Subject: UniStar Nuclear Energy, NRC Docket No. 52-016
Response to Request for Additional Information for the
Calvert Cliffs Nuclear Power Plant, Unit 3,
RAI 218 and RAI 229, Stability of Subsurface Materials and Foundations

Response to NRC Request for Additional Information

**RAI 218 Questions 02.05.04-03, 02.05.04-09, 2.05.04-10 and 2.05.04-15
and**

RAI 229 Questions 02.05.04-17 and 02.05.04-19,

Figure 12
Center Settlements for Buildings: Reactor Building (RB), Fuel Building (FB), Safeguard Buildings (SGB1, SGB23, and SGB4).

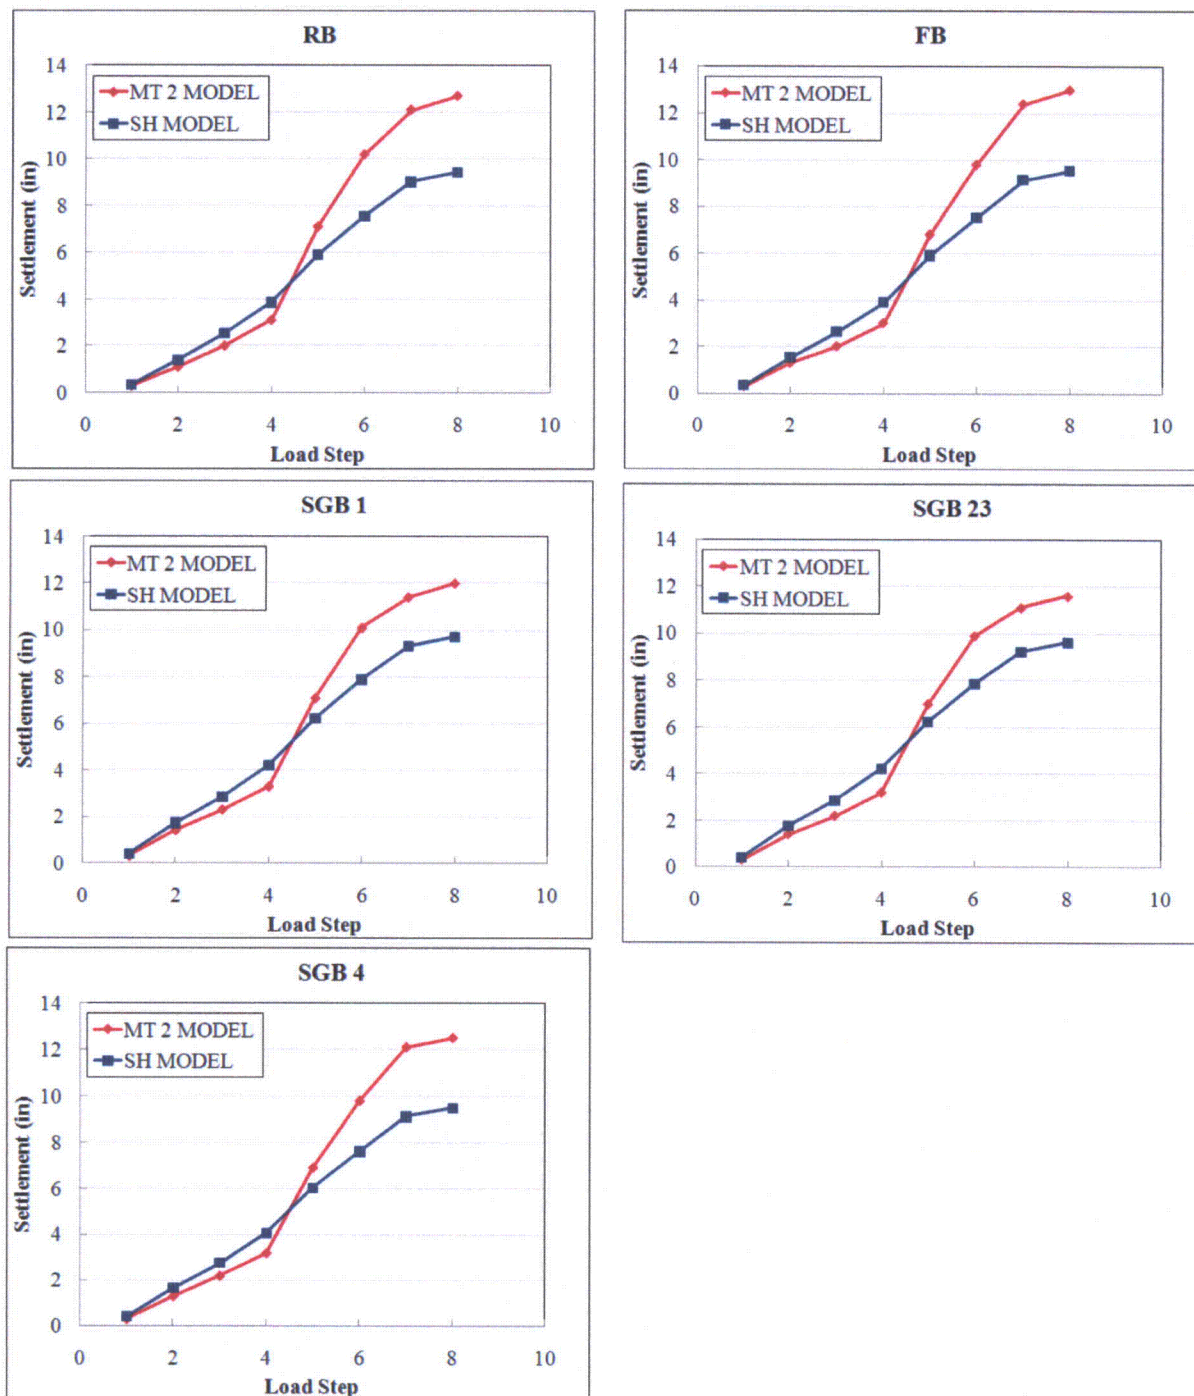
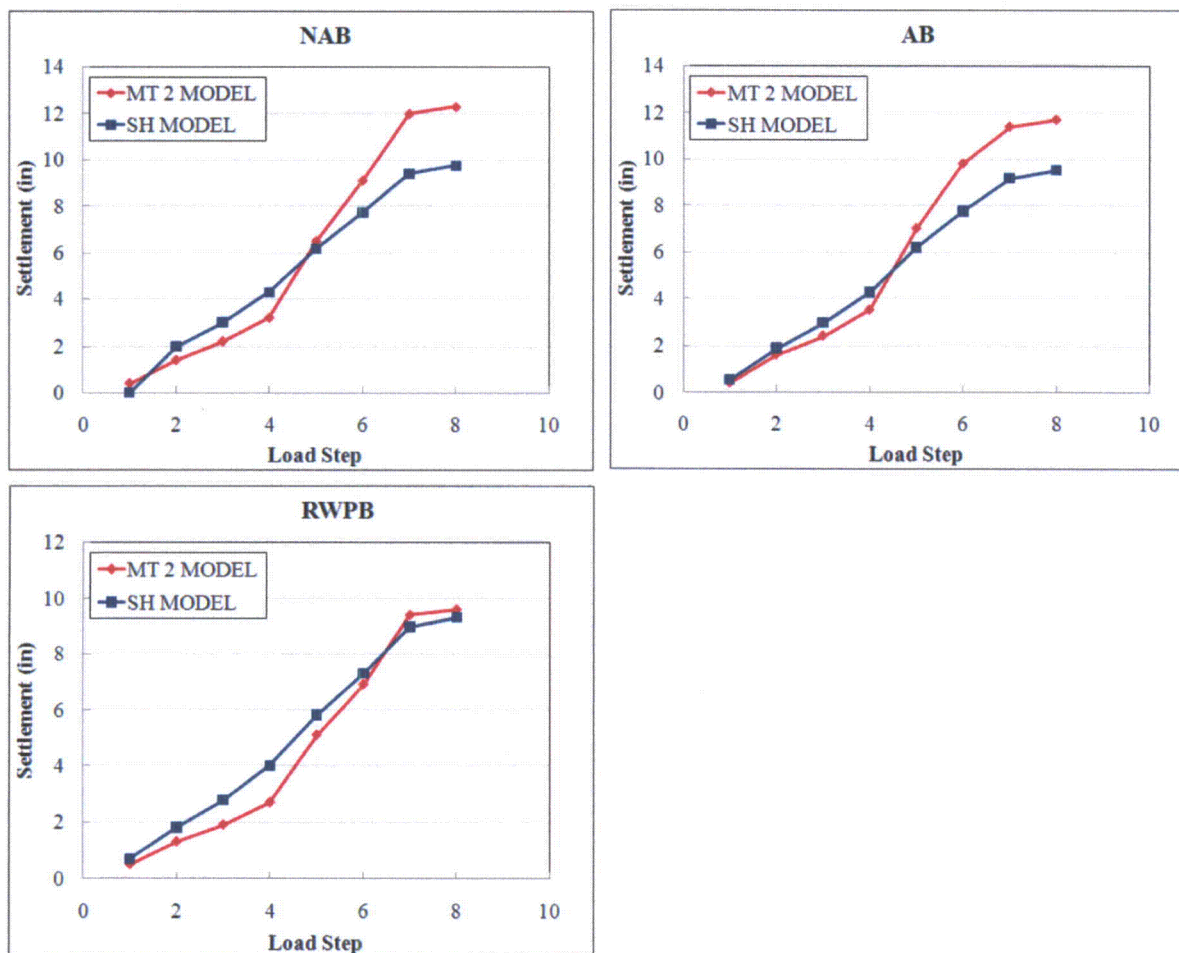
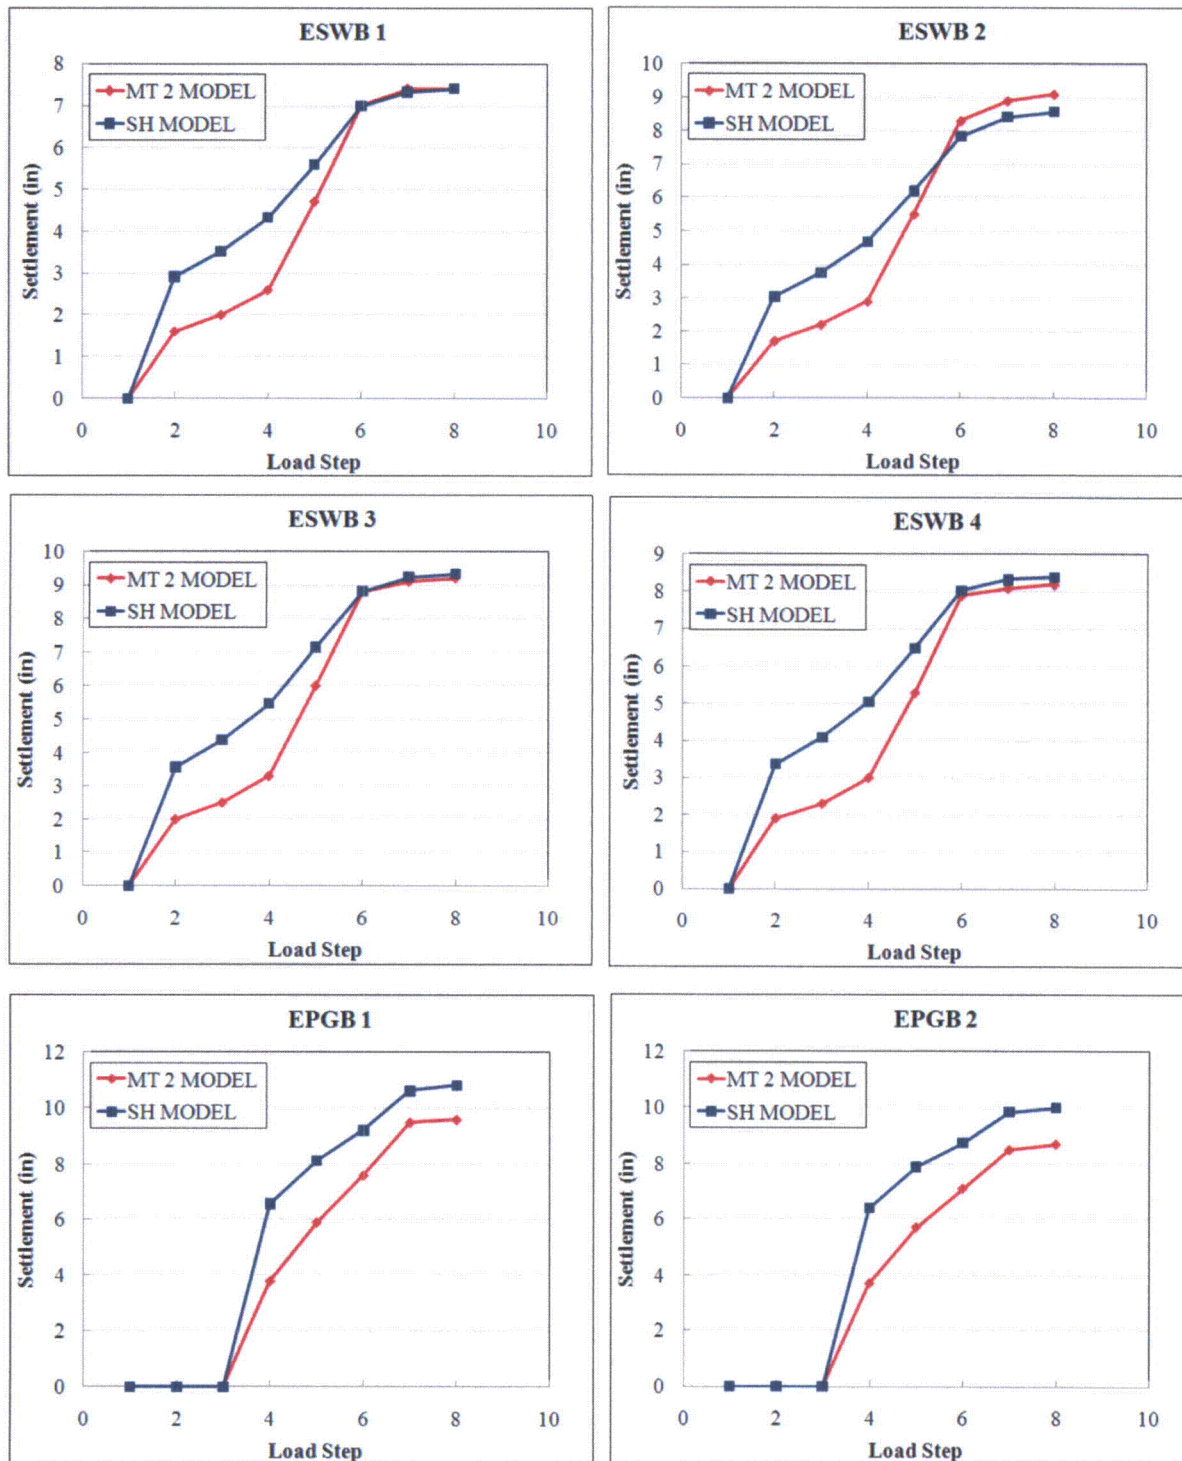
1. Please explain the adequacy of the initial stress conditions selected in your FEM settlement calculation.
2. Please evaluate the possibility of any additional settlement caused by seismic event at the site.
3. Please address the effects of soil parameter variation and spatial variability on your settlement analysis.
4. Please address differential settlement between the nuclear island and adjacent structures, and compliance with the U.S. EPR standard design.
5. Please justify the assumptions, especially the determination of stress increases in each layer, used in the hand calculation of settlement you performed.

The settlements obtained by MT2 and SH models are given in Figure 12 through Figure 14.

SH settlement predictions at the end of 8th step are in general less than MT2 settlement predictions. However, for some buildings, settlement prediction at the end of 5th loading step is larger according to SH model compared to that of MT2 model. This is due to fact that SH model assigns stiffness based on the stress level. As the mean effective stress underneath the foundation increases, the stiffness of the soil medium increases as well. This behavior can be captured by the SH model but not by the MT2 model.

This analysis indicates that MT2 model remains on the conservative side for the building center settlements except for the surface founded Emergency Power Generation Buildings (EPGBs). The structural fill underneath the EPGBs is 44.5 ft thick (= 76 - 41.5), and its placement is finished at the end of 4th step in the models, before the EPGB load is applied at the 5th step. Most of the EPGB displacement (more than 60%) is due to the fill. Before the EPGB construction begins, displacement in the fill would be leveled. In other words, the settlement estimates from the models are already conservative.
